**Mario J. DiGregorio  
Professional Wetlands Scientist  
913 West Falmouth Highway  
Falmouth, MA 02540  
(508) 364-1746**

Via E mail & Postal Priority  
Scituate Zoning Board of Appeals  
Scituate Town Hall  
600 Chief Justice Highway  
Scituate, MA 02066

Re: 126 & 132 Chief Justice Highway  
DEP # SE 068-1988

East Wetland Connector  
Hollstein Property  
10-8-07

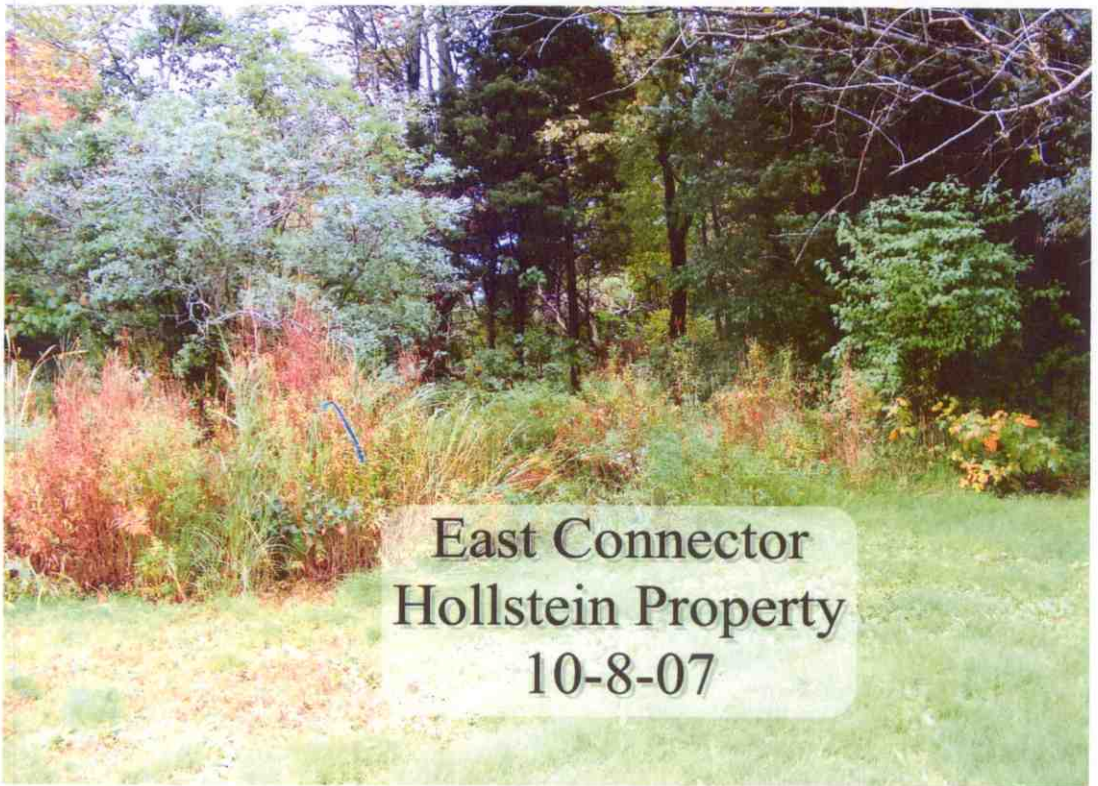
3. There were also important indicators of wetland hydrology in this connector area, including stained leaves, drainage patterns in the soil and fluted trunks with buttressed roots.

4. In my professional opinion, *the eastern connector to the marsh renders the claimed ILSF a Bordering Vegetated Wetland ("BVW") (310 CMR 10.55)*, a designation with dramatic ramifications to the project in question or any project. Performance standards require that any fill in BVW be replicated out of the resource area in the site's upland. The replication must restore lost wildlife habitat, not just lost volumetric flooding. Replication under State standards must be a minimum of 1:1; under the stricter Scituate wetlands by-law, replication must be no less than 2:1.

5. The eastern wetland connection was pointed out to members of the Conservation Commission and ZBA on October 8. At that time, there appeared consensus that the connector exists and that the resource area is contiguous with the previously designated ILSF.
